Subject: RE: 24/0186 [NOT PROTECTIVELY MARKED]

Please see comments below regarding the application **24/0186**

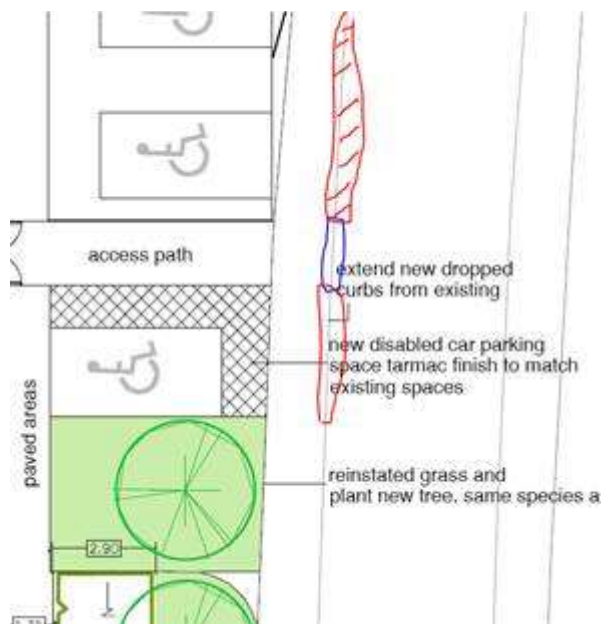
- The applicant should be made aware that the proposed scheme will require a highway licence and should therefore contact the council's Highway Maintenance Department regarding the approval of a section 184 license in relation to any the proposed vehicular crossovers. This this must be obtained separate to this planning permission.
- Disabled bay is acceptable in terms of size
- In regards to the dropped kerbing. I have sketched something below that I would like to see.
 - Blue should be full height HB2 kerbing across the length of the access path
 - Red hatched is existing dropped kerbing
 - Red (NOT hatched) is proposed dropped kerb and transition kerbing across the length of the new bay
